Project	IEEE 802.16 Broadband Wireless Access Working Group < http://ieee802.org/16 >	
Title	AAS enhancements for OFDMA PHY	
Date Submitted	2004-04-15	
Source(s)	Dale Branlund ¹ Adam Kerr ² Zion Hadad ⁴ Lalit Kotecha ¹ John Liebetreu ³ Paul Petrus ² Mike Webb ¹ Yigal Leiba ⁴	mailto:dbranlund@beamreachnetworks.com adam@arraycomm.com zionh@runcom.co.il lkotecha@beamreachnetworks.com John.Liebetreu@intel.com petrus@arraycomm.com mwebb@beamreachnetworks.com yigall@runcom.co.il
	¹ BeamReach Networks ² ArrayComm Inc. ³ Intel Corp. ⁴ Runcom Technologies Ltd.	
Re:	IEEE P802.16-REVd/D4-2003	
Abstract	This contribution introduces AAS enhancements for OFDMA PHY as an optional feature	
Purpose	Adopt into P802.16d/D5 draft.	
Notice	This document has been prepared to assist IEEE 802.16. It is offered as a basis for discussion and is not binding on the contributing individual(s) or organization(s). The material in this document is subject to change in form and content after further study. The contributor(s) reserve(s) the right to add, amend or withdraw material contained herein.

8.4.4.7 AAS frame structure

Figure 1: AAS Diversity Map Frame Structures

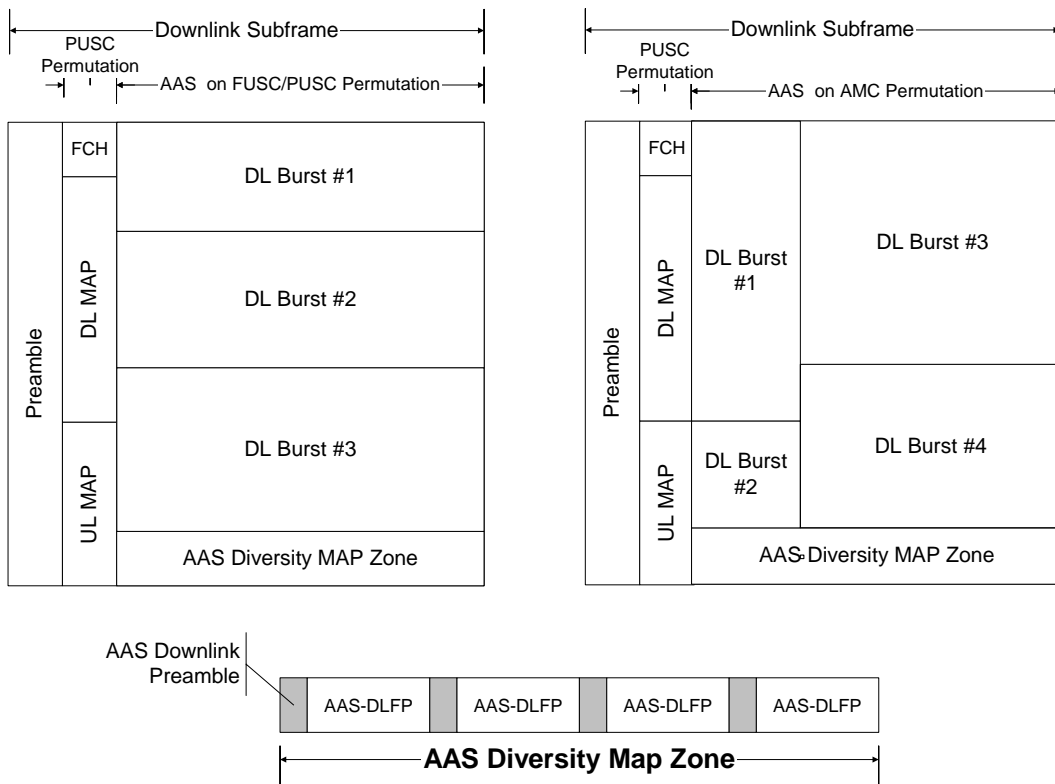
[Replace Section 8.4.4.7 “Optional Active DL AAS Scan” in IEEE802.16-REVd/D4 with the following section.]

The two highest numbered subchannels of the downlink frame may be dedicated at the discretion of the base station for AAS diversity map zone. When these subchannels are used for this purpose, they should not be allocated in the normal DL MAP message and shall be used only on the AAS portion of the downlink subframe. These subchannels will be used to transmit the AAS-DLFP in the AAS Diversity Map Zone as shown in Figure 1. The AAS-DLFP is transmitted with a known modulation and coding, namely QPSK 1/2-rate with 2 repetitions.

The AAS Diversity Map Zone shown in Figure 1 will carry repeated transmissions of the AAS downlink preamble and the AAS-DLFP. The AAS-DLFP carries information on the frame number, UCD, DCD, and other AAS specific parameters. It also carries two compressed AAS map IEs, either uplink or downlink maps. Table 1 provides the AAS-DLFP structure. The compressed map IEs can point to broadcast allocations that carry information such as the DCD or UCD messages, normal DL MAP or UL MAP messages, or UL allocations for initial ranging, or initial bandwidth allocations for specific CIDs.

Figure 3 Frame Layout in the AAS Region

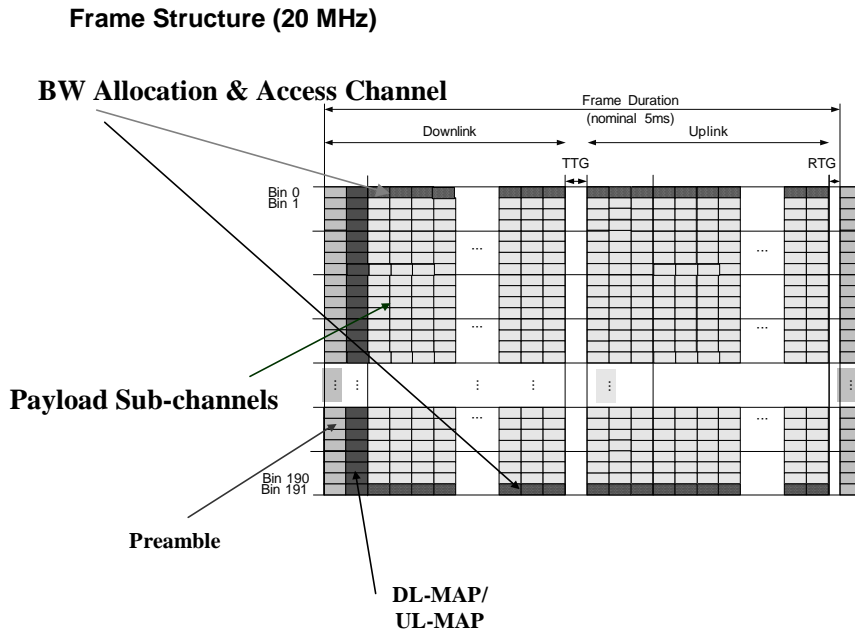
At least one BW allocation/access (BWAA) channel is allocated in the TDD AAS frame for network entry, ranging, bandwidth request, and AAS MAP communications. One BWAA channel is shown in Figure 3. Up to 4 of these channels may be provisioned as indicated in AAS-DLFP2. The location is identified in the UL-MAP as Initial-Ranging (UIUC=12), but shall be marked by an AAS initial ranging CID to ensure that no non-AAS subscribers use this region for initial ranging. The channel is formed using the first and last partition in the frame to improve channel reliability and SINR through beamforming and diversity combining methods. In the case that multiple BW allocation/access channels are specified, the first channel shall be constructed from the first partition and the partition indexed by $P-(N_{ac}-1)$ where P is the number of partitions and N_{ac} is the number of BW allocation/access channels provisioned. AAS with FDHC (section 8.4.8.3) is used as the combining method on the BWAA channel. The channel is power boosted.

Figure 4 Downlink BW Allocation/Access Channel

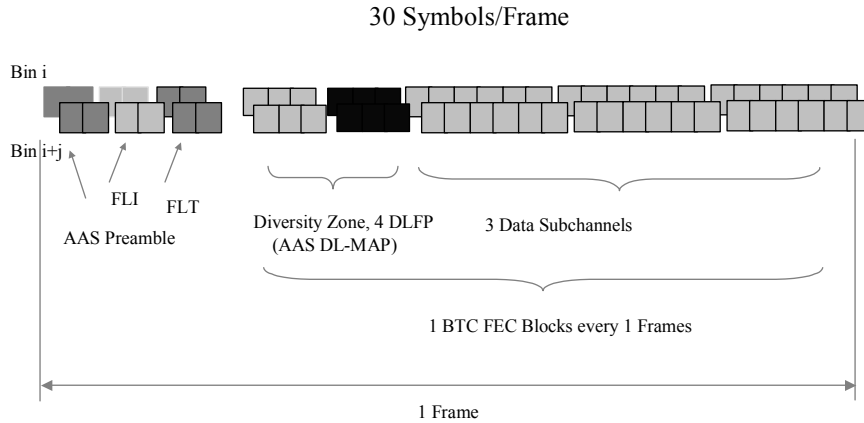
The structure of the BW allocation/access channel is illustrated in Figure 4. In this figure, the two partitions forming the BW allocation/access channel are shown. This channel immediately follows the FUSC/PUSC DL and UL Map region in the downlink frame and is identified uniquely by the AAS AMC preamble. The channel shows a DLFP zone using 4th-order beam-pattern diversity and a payload region of 6 sub-channels for the frame duration illustrated by this example. Two AAS control signals are also shown (FLI and FLT) which will be described the text below. Table 4 provides the AAS-DLFP2 data structure. This six byte data structure is repeated four times. It provides the necessary information for initial ranging and for reception of the initial ranging response messages to included the basic CID. This CID maps one-to-one into the Reverse Link Training (RLT) sequence index. The RLT is transmitted by the SS and is used to adapt the base station array. The data sub-channels shown in Figure 4 support the compressed DL_MAP and UL_MAP messages per the format in Table 1, 2 and 3 above.

Figure 5 Reverse Link AAS Sub-Frame Structure Showing RLT Signaling

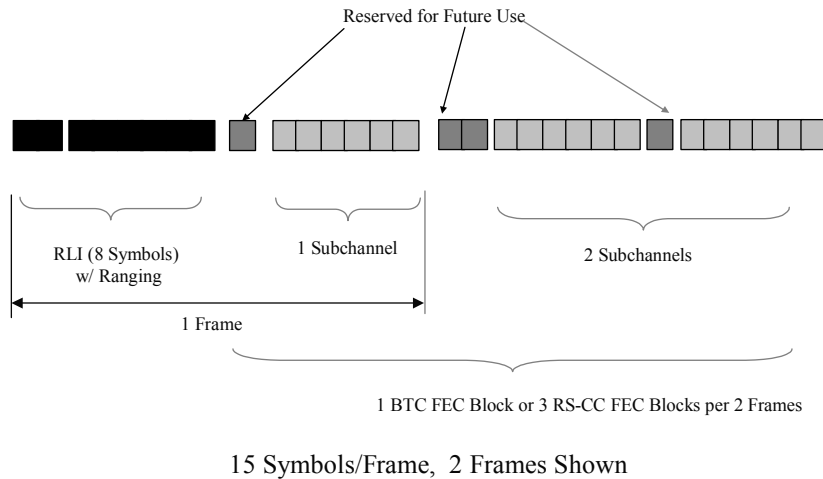
The reverse link partition in the TDD RL sub-frame is shown in Figure 5 for one of P (P=192 for 20 MHz) partitions. The reverse link in this example provides 15 symbol slots and is organized as two AAS sub-channels. One of the 2 AAS sub-channels contains one AAS reverse link control signal that is transmitted once every multi-frame. A multi-frame is 1, 2, or 4 frames.

Two physical layer control signals are defined for the reverse link. The first is a reverse link training (RLT) signal, which allows a SS to send an AAS training signal to the base for a given sub-channel. The RLT provides the time-bandwidth product necessary to adapt up to 12 antennas at the base station. The RLT signal shall occur at the beginning of the reverse link frame as shown in Figure 5 and is sent alternately every frame, every other frame or every fourth frame as provisioned by the “multi-frame parameter” in the AAS-DLFP2. MAC messages or traffic data are sent after the RLT in the first data sub-channel and in subsequent sub-channels thereafter also shown in Figure 5. The RLT occupies a maximum of 8 symbol slots per partition providing 64 QPSK symbols for base station training. When used with fewer antennas, the RLT may be set to 32 QPSK symbols spanning 4 symbol slots to minimize training overhead. In addition, the RLT symbol sequence may span two adjacent bins. Accordingly, supported RLT cluster configurations are 1 x 8, 1 x 4, 2 x 4, and 2 x 2 (bins x symbol slots).

Figure 6 Forward Link Sub-Frame Structure showing FLI and FLT Signaling

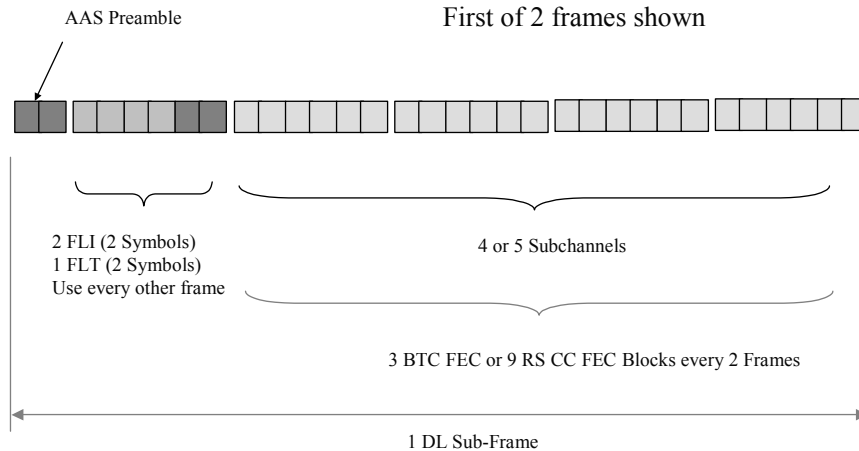
The forward link partition is shown in Figure 6 for one of 192 partitions. The forward link partition in this example provides 33 symbol slots and is organized as five AAS sub-channels. One of the 5 AAS sub-channels contains three forward link control signals of two types applied once every multi-frame.

There are two types of AAS control signals used by the forward link. The first is the forward link initiation (FLI) signal. The FLI signals to the SS to initiate communications on traffic sub-channels. This “paging” and “link initiation” signal is shown for the downlink frame structure shown in Figure 6 and has coding unique to a SS. One or two FLI signals are provisioned per AAS signaling sub-channel in every multiframe frame. Each FLI signal modulates 16 tones (1 bin x 2 symbol slots) with 16 QPSK symbols. The FLI provides 12 dB (or 15 dB with soft combining) of processing gain to signal subscriber stations without directed beam steering knowledge.

Figure 7 PHY Control Signal Sequence Diagrams

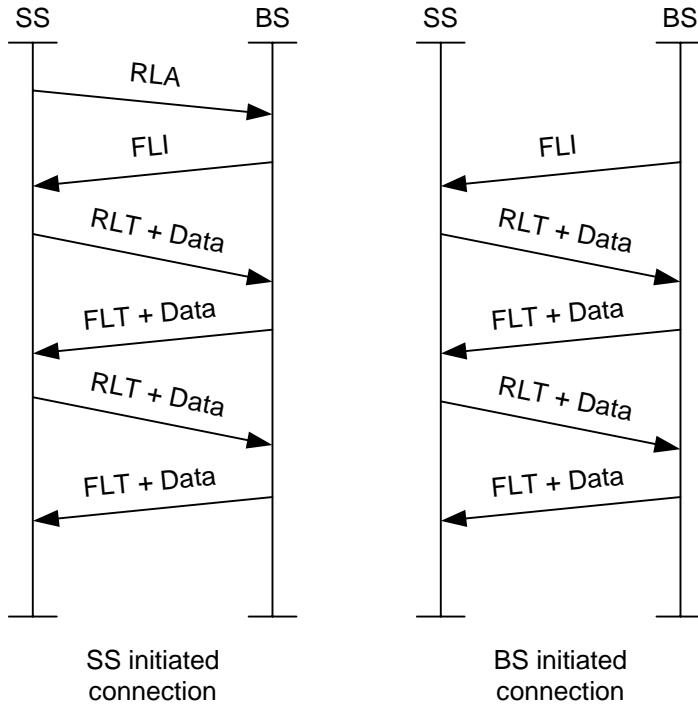
Having defined the control signaling above, the controlling sequences can now be described. The AAS physical layer is controlled via the signaling sequences described below. Table 5 provides a list of sequence actions keyed to the sequence diagram shown in Figure 7. For the first case, we consider a base station initiated data flows subsequent to the receipt of the DL_MAP and UL_MAP.

The diagram on the left side of Figure 7 also illustrates the directed SS initiated connection. In this case an RLA at step 0 is sent to the base station. The base station responds with a map allocation on the BWAA channel and FLIs and data in the appropriate data regions. The control sequence then is identical to the base initiated connection.
